Replacement of 8DB 355 037-691 by 8DB 355 040-451

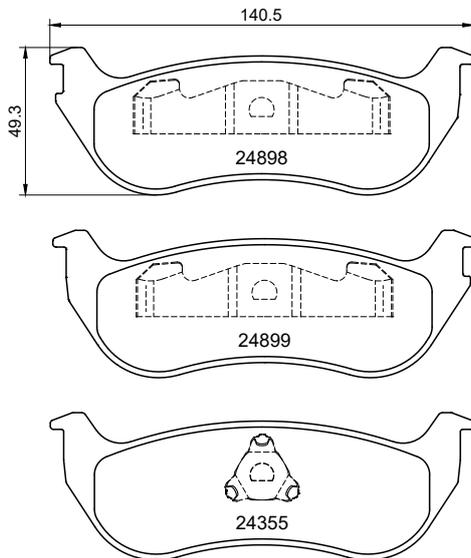
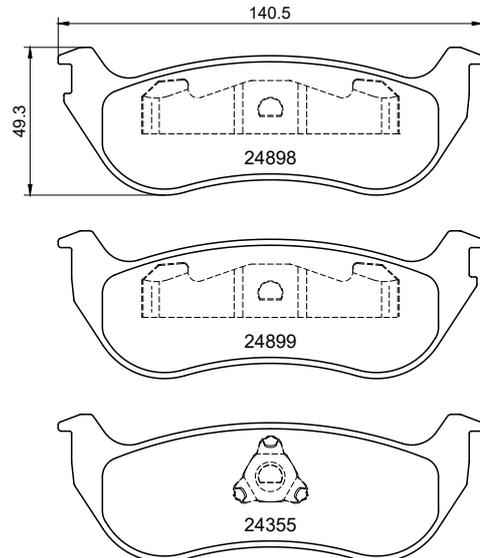
Hella Pagid is now able to harmonize the references 8DB 355 037-691 and 8DB 355 040-451. It was proven that 8DB 355 040-451 can also cover the applications of 8DB 355 037-691. Therefore Hella Pagid will replace 8DB 355 037-691 by 8DB 355 040-451.

Hella Pagid decided to reduce the thickness of 8DB 355 040-451 to 14,0 mm, which makes the two references equal and therefore Hella Pagid decided to harmonise 8DB 355 037-691 with 8DB 355 040-451. There will be no difficulties during installation and operation.

As usual, existing stock of 8DB 355 037-691 can be sold out without any problems.
